CORRECTIONS for REV1.0 Quantizer LCD

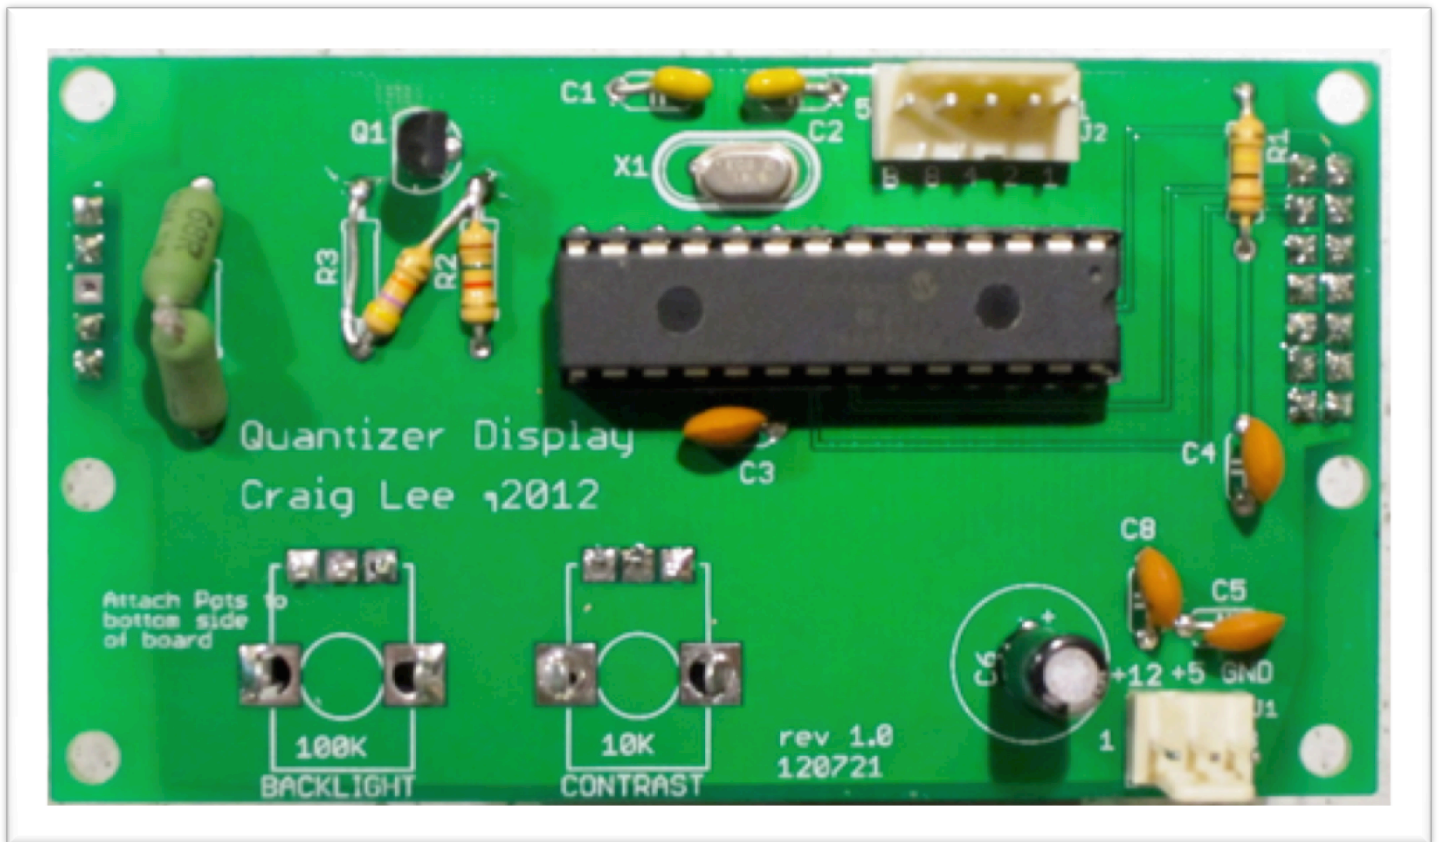
Corrections need to be made around the brightness transistor
The silk is reversed, install the 2N222 reversed from the outline
Install a jumper wire across R3
Install the 47K Resistor from the lower pad of R3 to the upper pad of R2 (1K)

Contrast is labeled 10K but should be 20K
